Work Order ID: 120864

Item Name: Fwd Crosstube

DRAWING NO. D407-667-145	TITLE CROSSTUBE ASS'Y (407 HIGH FWD)	REV. C	DART AEROSPACE LTD ENGINEERING ORDER		D.E.O. NO. D407-667-145-C-1	SHEET NO. SHEET 1 OF 1	SCALE NTS
DRAWN 97	CHECKED ASS	MFG. APPR. 18	APPROVED WD		DE APPR. ##		
DATE 11.07.15	DATE 11.07.22	DATE 11.07.22	DATE 11/07/22		DATE 11.07.21

DRAWING NO. D407-667-145	TITLE CROSSTUBE ASS'Y (407 HIGH FWD)	REV. C	DART AEROSPACE LTD ENGINEERING ORDER		D.E.O. NO. D407-667-145-C-2	SHEET NO. SHEET 1 OF 1	SCALE NTS
DRAWN AJS	CHECKED	MFG. APPR.	APPROVED		DE APPR.		
DATE 12.08.02	DATE 12.08.02	DATE 12.08.02	DATE 12.08.02		DATE 12.08.02

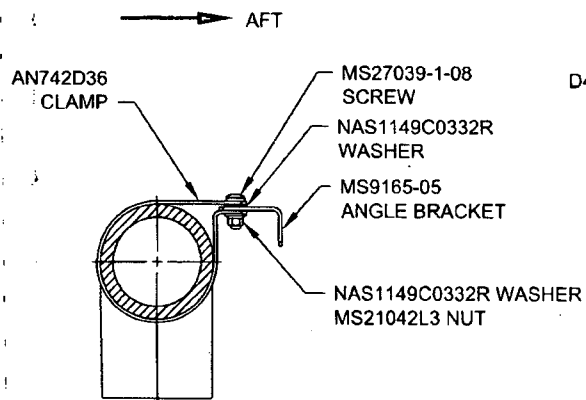
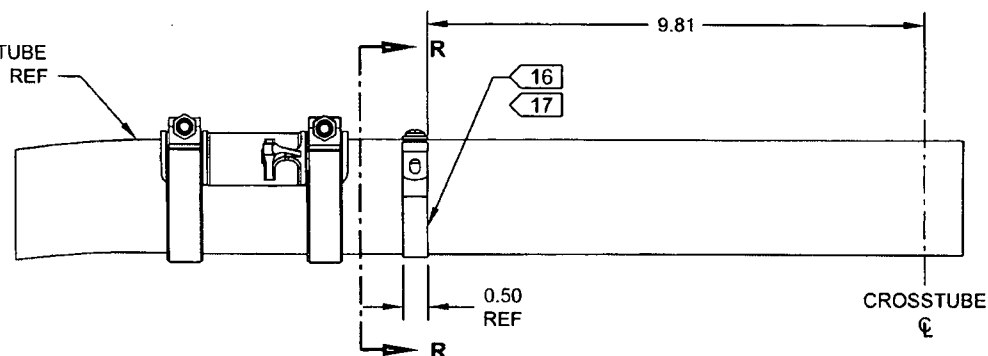
ADD ELECTRICAL GROUNDING STRAP

ITEM	QTY	PART NUMBER	DESCRIPTION
1	X	D407-667-145	CROSSTUBE ASSEMBLY (407 HIGH FWD)
10	2	AN742D36	CLAMP
11	2	MS9165-05	ANGLE BRACKET
12	2	MS21042L3	NUT (OR MS21042-3)
13	2	MS27039-1-08	SCREW
14	4	NAS1149C0332R	WASHER (OR AN960C10L)

**RELEASED**  
CP 12.08.17  
ECN 12-631
